ECN/PCN No.: 4548

Product Description: 32.768KHZ SMD LOW PROFILE CRYSTAL	Abrakon Part Number / Part Series: ABS09	<input type="checkbox"/> Documentation only <input checked="" type="checkbox"/> Series <input checked="" type="checkbox"/> ECN <input type="checkbox"/> Part Number <input type="checkbox"/> EOL
Affected Revision: J	New Revision: K	Application: <input type="checkbox"/> Safety <input checked="" type="checkbox"/> Non-Safety

Mechanical dimensions

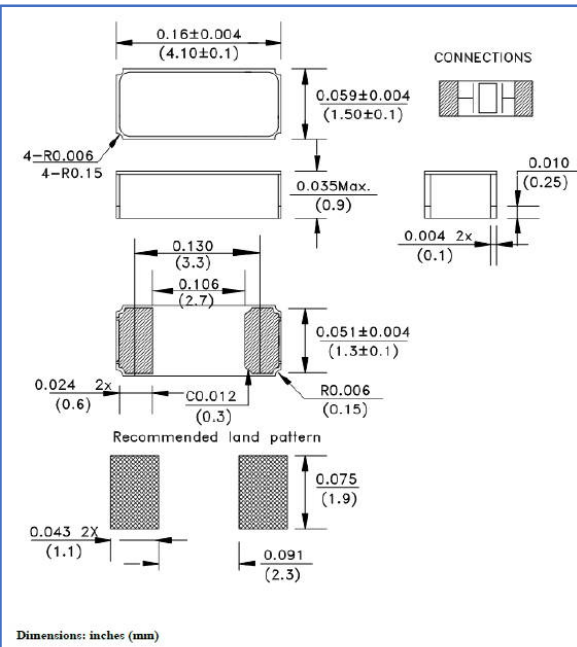
Prior to Change:

Mechanical dimensions

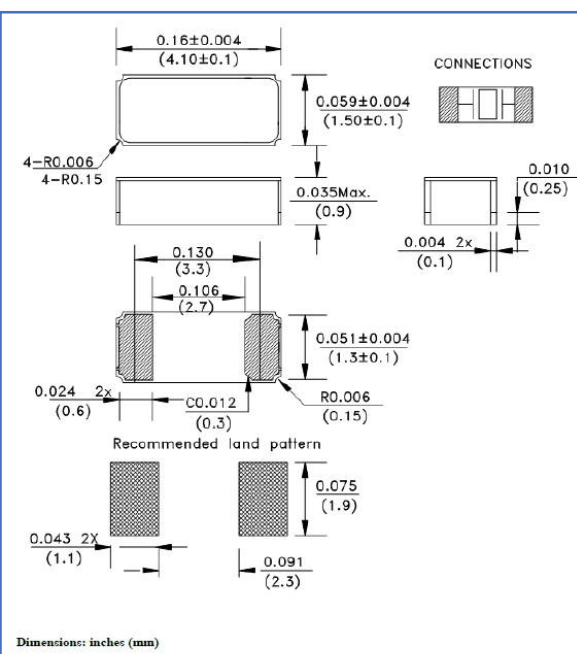
After Change:

Abracon introduced additional manufacturing sources to ensure product availability and to be in a better position to meet long term customer demand. Added an alternative bottom packaging structure to reflect the product produced by all manufacturing sources.

Alternative Packaging 1:

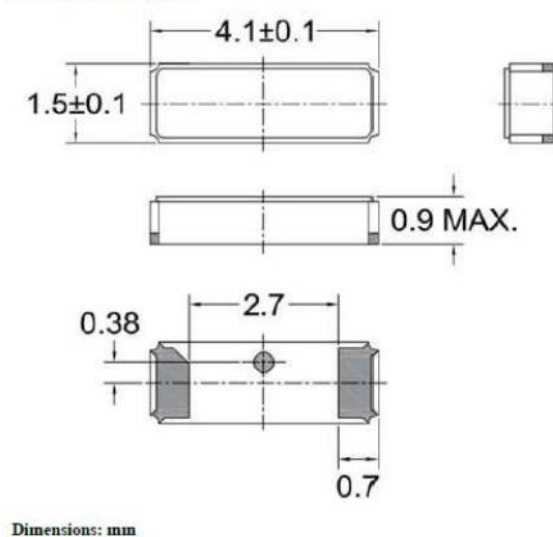
The added bottom packaging structure does not impact the electrical performance of the device.
